802.1Qau Draft 1.0 Ballot Issues

Version 2

Vote summary and Issues

Issue: End station Fig. 31-2: Input

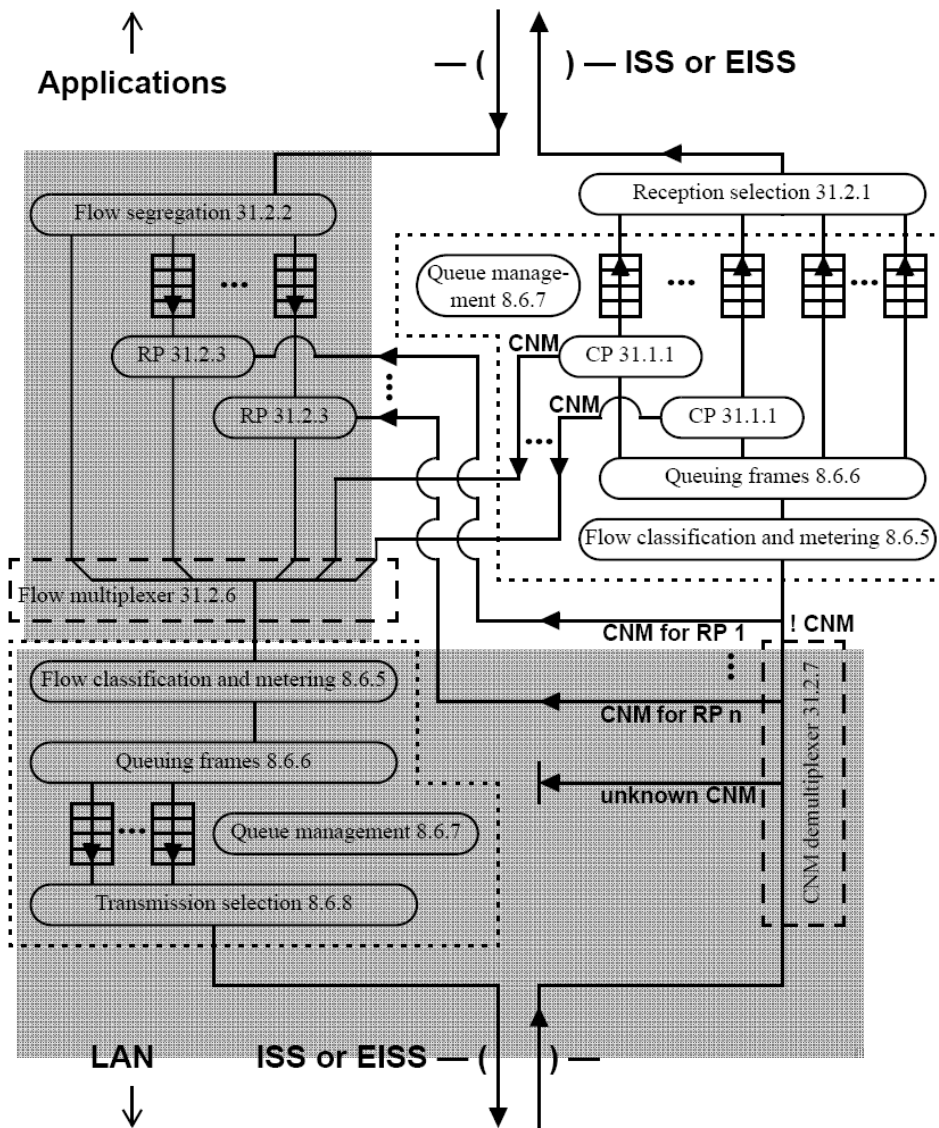
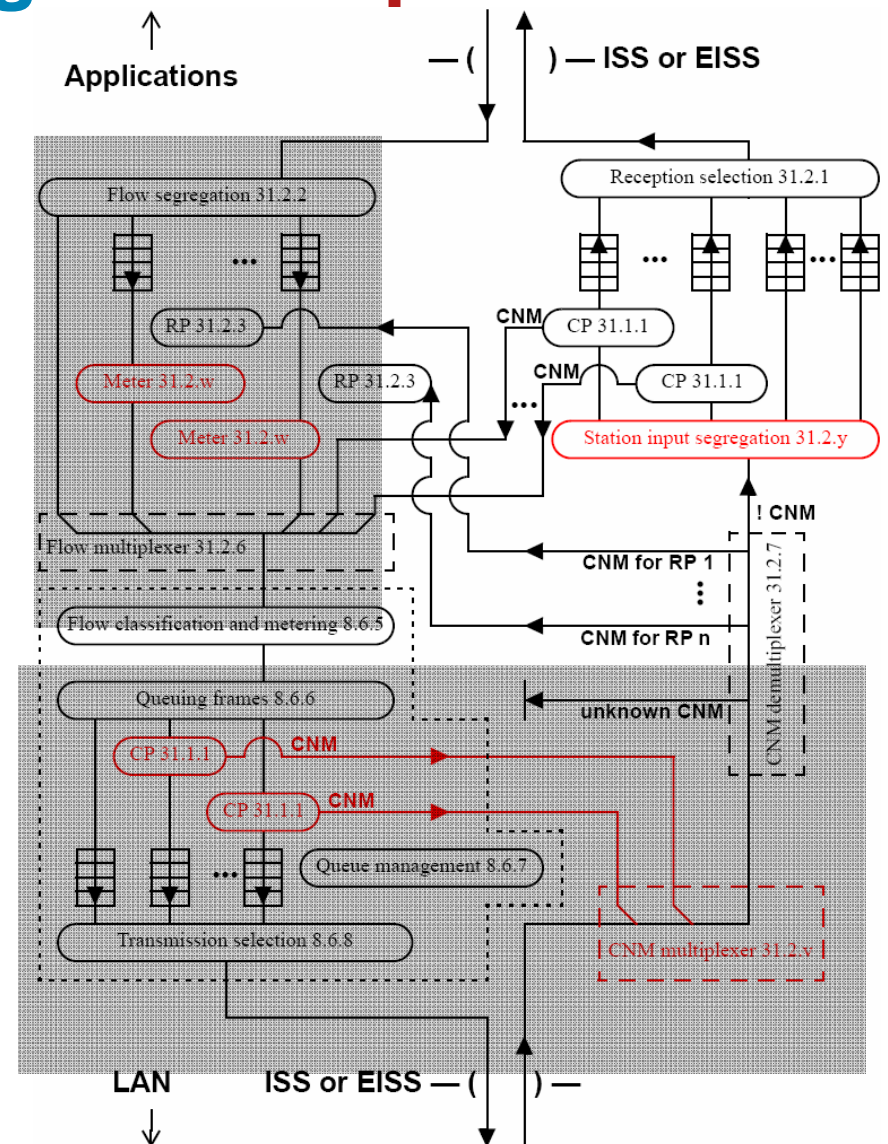
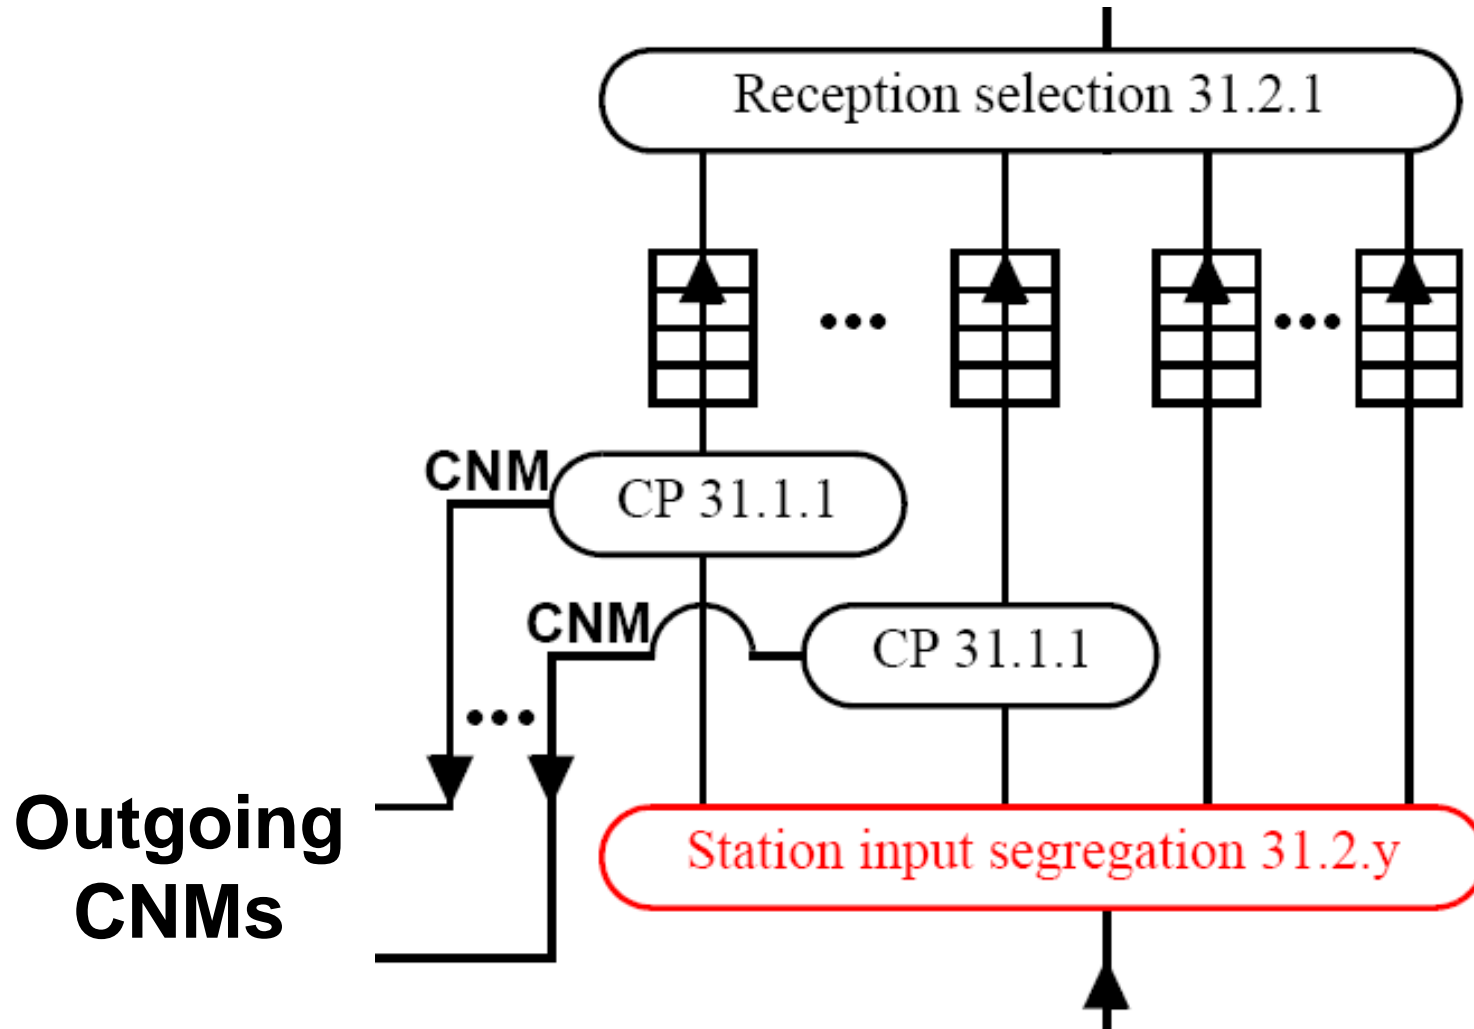
- In Draft 1.0, the end station must have the same per-priority queues and CPs that a Bridge must have.
- But, an end station may not need to issue CNMs based only on priority; it may have the ability to issue CNMs based on any other granularity, e.g. per-application.
- Therefore, we will not specify how the end station segregates traffic among CPs.

- In Draft 1.0, the end station must have the same per-priority queues and CPs that a Bridge must have.
- But, an end station may not need to issue CNMs based only on priority; it may have the ability to issue CNMs based on any other granularity, e.g. per-application.
- Therefore, we will not specify how the end station segregates traffic among CPs.

Issue: End station Fig. 31-2: Choice 1

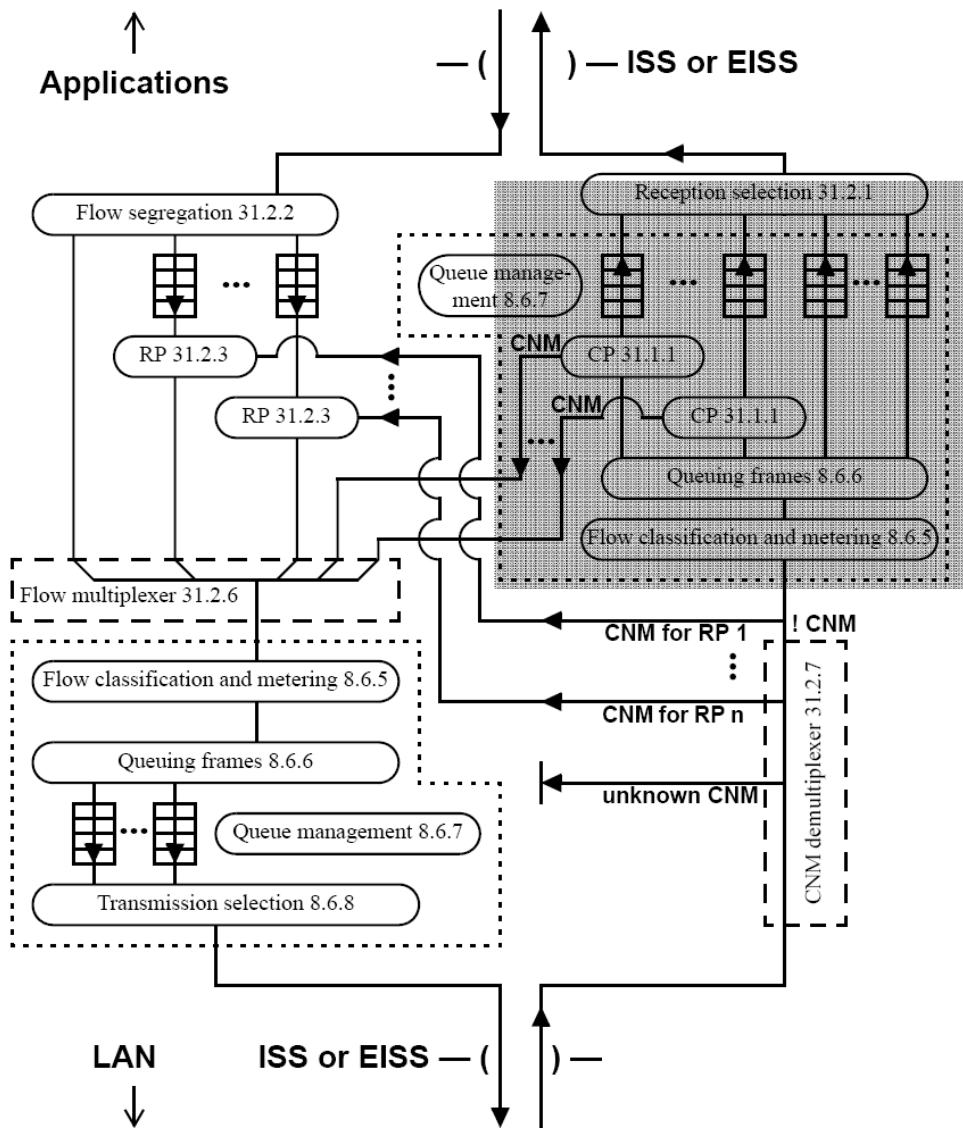
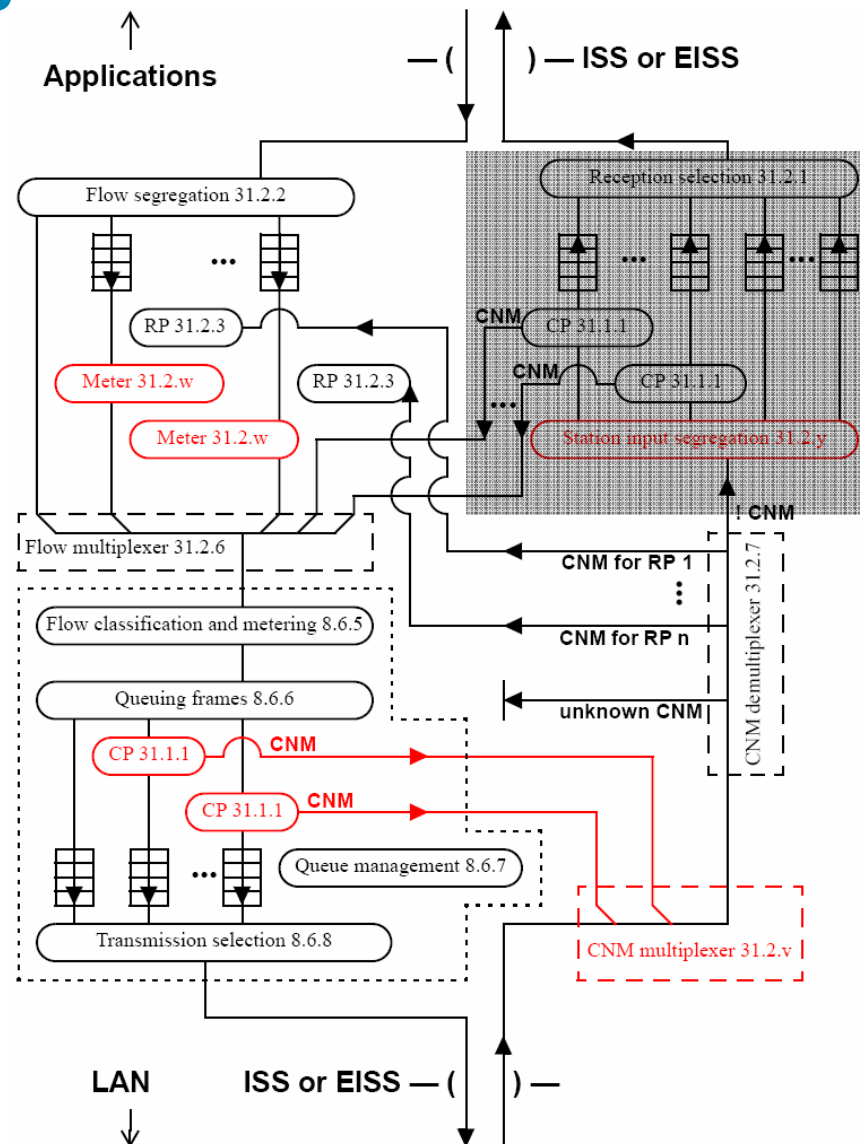
- In Draft 1.0, a Flow queue can have an attached RP.

The RP state machine determines the current flow rate.

But, there is no function specified to actually drain the queues at that flow rate.

- Therefore, we transmit CNMs internally, to prevent priority queue overflow.
- This may use a faster sampling rate (e.g., 25% instead of 1%).
- From outside the box, it is impossible to tell whether the CNMs are actually generated.

Issue: End station diagram, Fig. 31-3

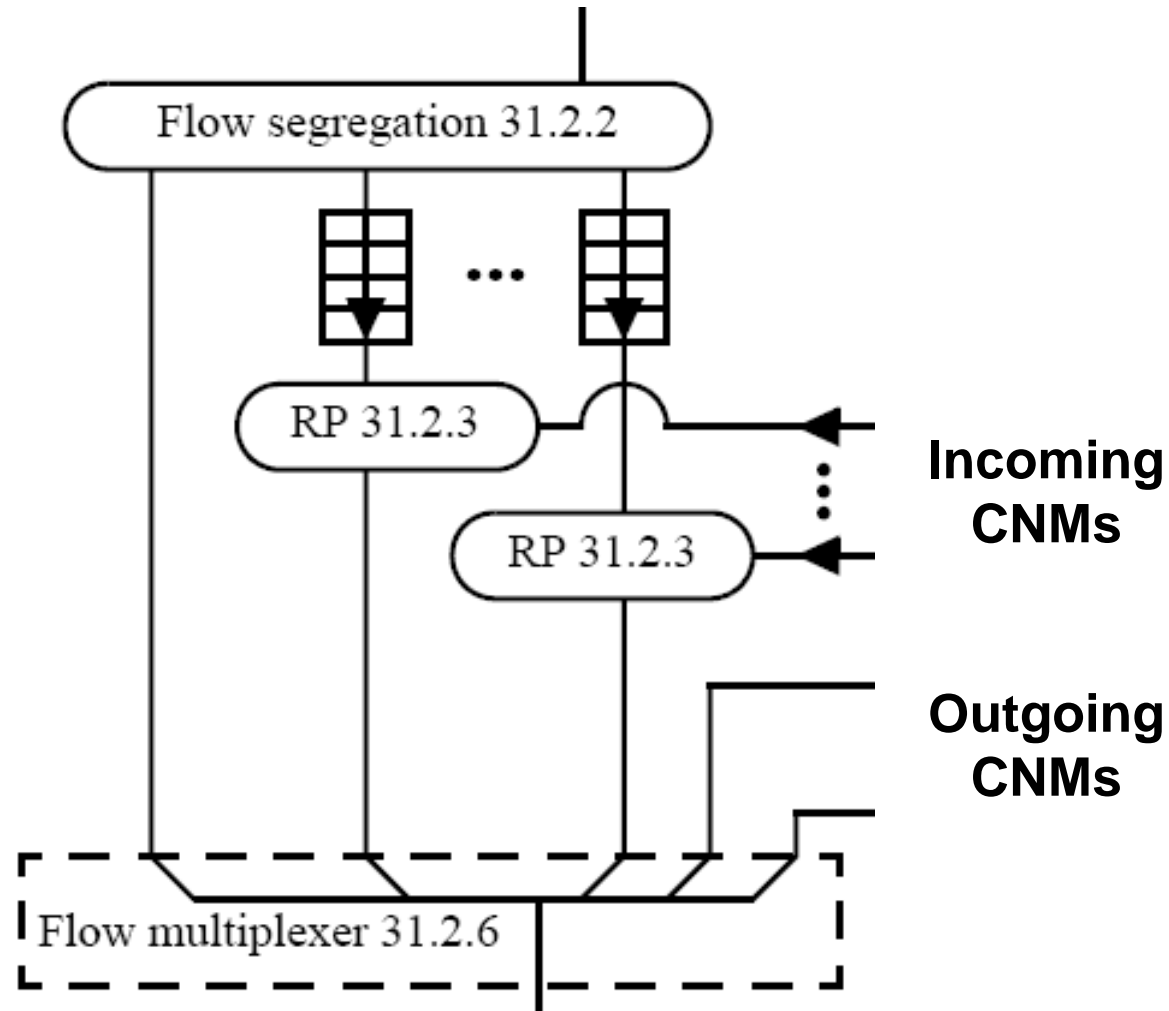
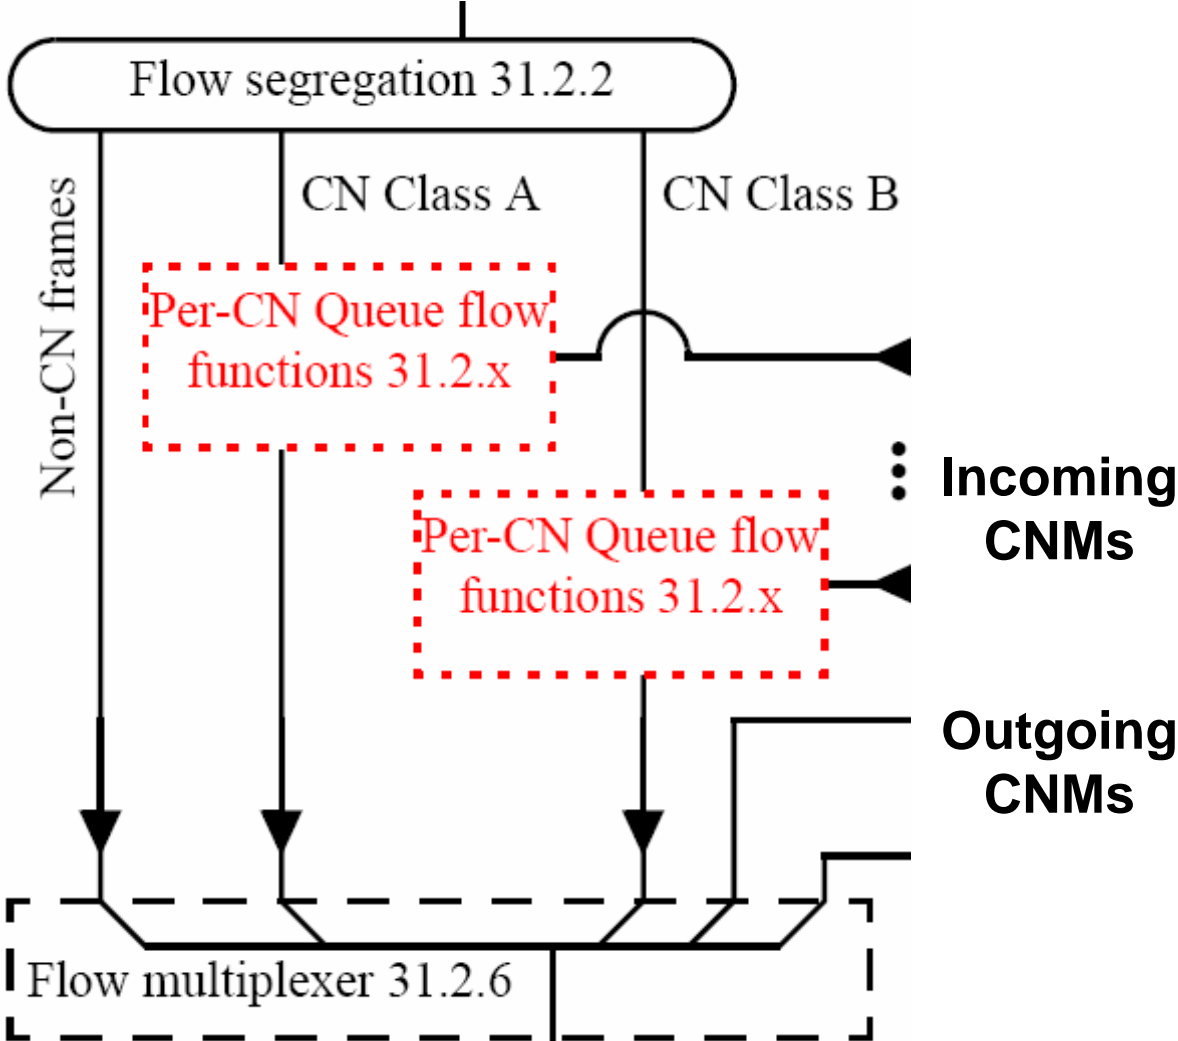
- In Draft 1.0, a Flow queue can have an attached RP.

The RP state machine determines the current flow rate.

But, there is no function specified to actually drain the queues at that flow rate.

- Therefore, we split the RP functions up by CN queue, one Per-CN queue function per CN priority queue.

- Non-CN traffic bypasses the Per-CN Queue flow functions.
- There is one Per-CN Queue flow function for each CN priority queue.
- More than one CN Class can be directed to the same priority queue.
